John Kiker Fishers Cove Public Hearing 8/21/19 Information Sources

Fishers Cove Storm Water System

Model Data vs. Lewes Code Impervious Surfaces

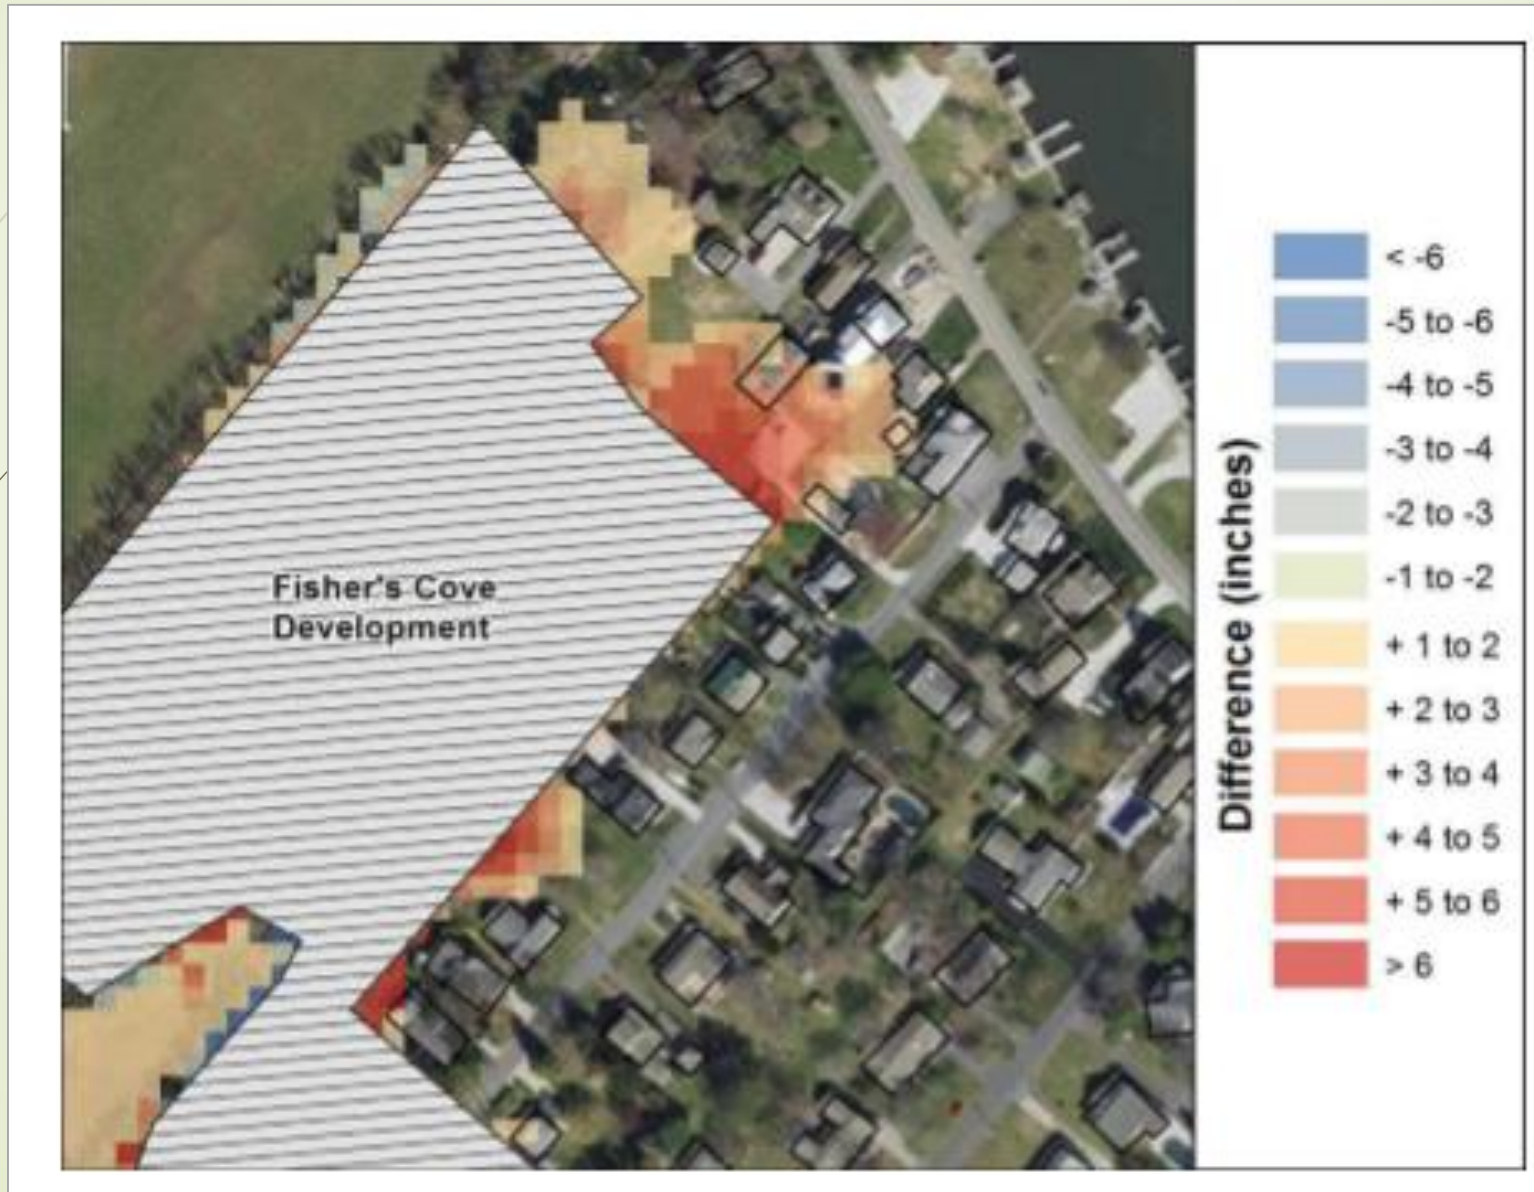
- ▶ 2-Yr Coastal Storm + 100-Yr Rain Model
- ▶ Model used preliminary drawings
 - ▶ Construction on 19% of the lot - 28% impervious + Rodney = 930,000 gallons
 - ▶ 930,000 gallons on a football field = 25.9 "
- ▶ Lewes building code allows
 - ▶ Construction on 65% of the lot - 51% impervious + Rodney = 1,416,000 gallons
 - ▶ 1,416,000 gallons on a football field = 43.7 "

Differences in Model Flood Depth at 17.5 Hour

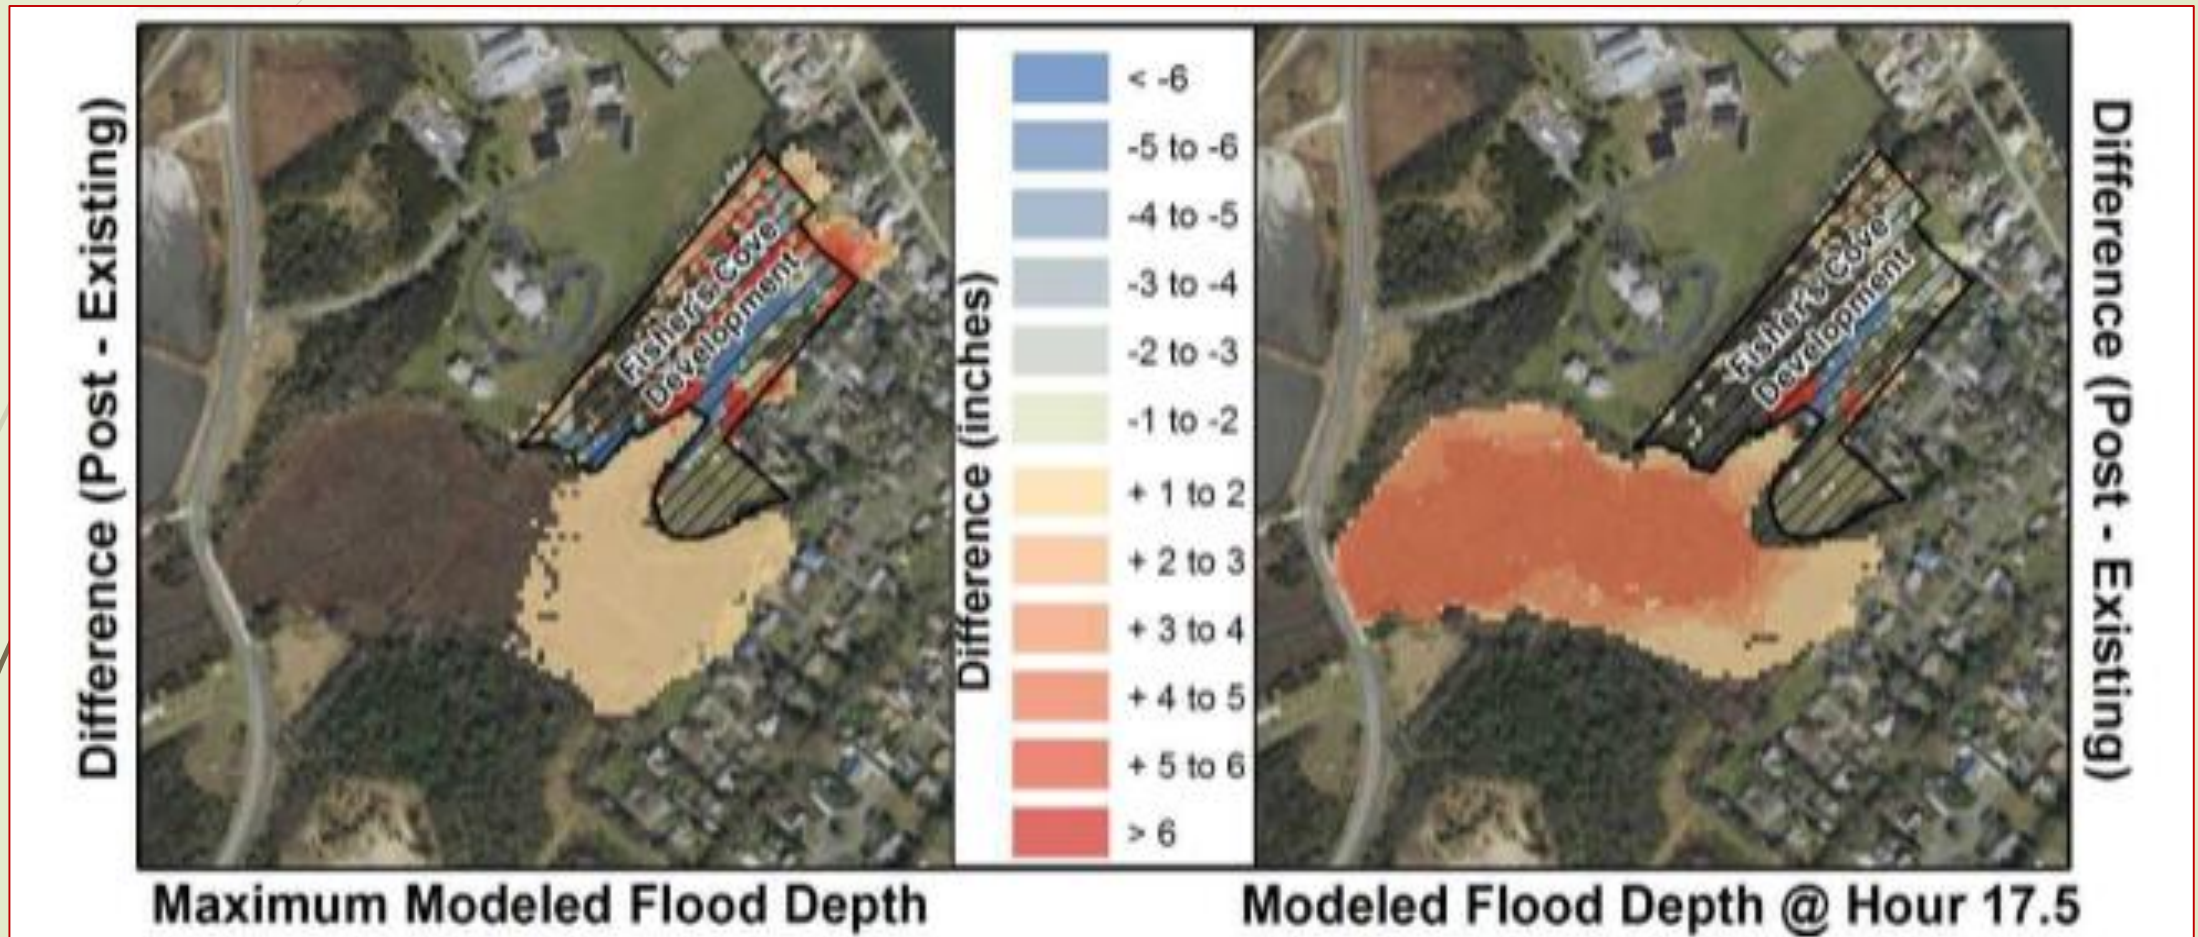
- ▶ Water varies by 5"
- ▶ One hour prior to peak flood
- ▶ Lagoon had not crested from the storm event at 17.5 hour
 - ▶ 7.6' MLLW or 4.93' NAVD88 high tide
- ▶ After peak high tide model difference was 1"

Model uses 2' high tide reduction 12 hours after peak tide
Page 23 figure 6.2

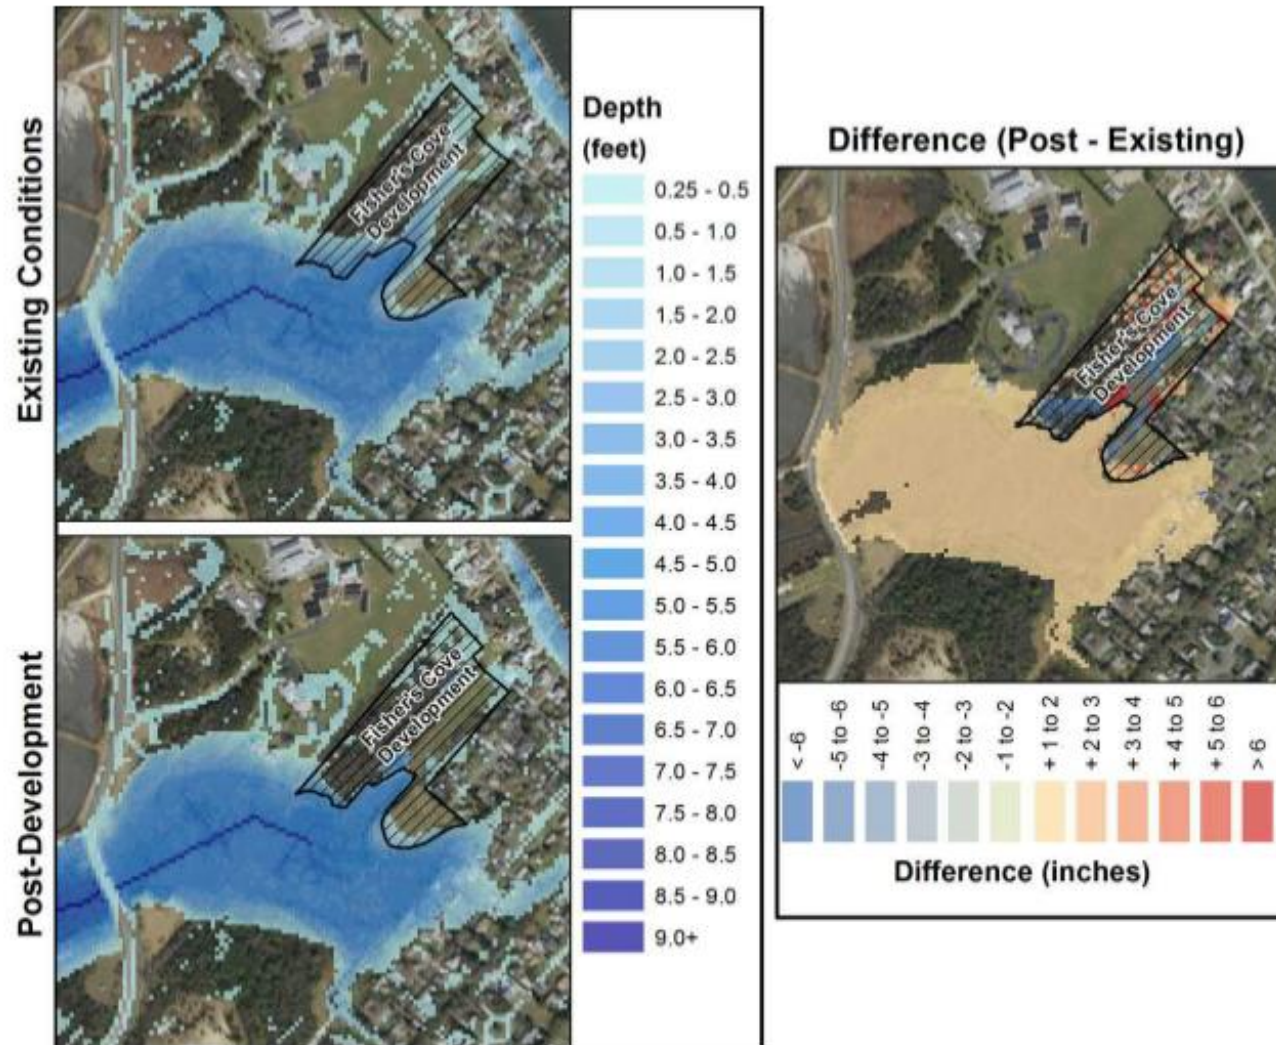
- **Models under estimate flooding**
 - Unproven storm water system
 - Impervious surface calculations
- Excluded from the models
 - Wind speed and direction
 - Consecutive high tides (Nor'easter)
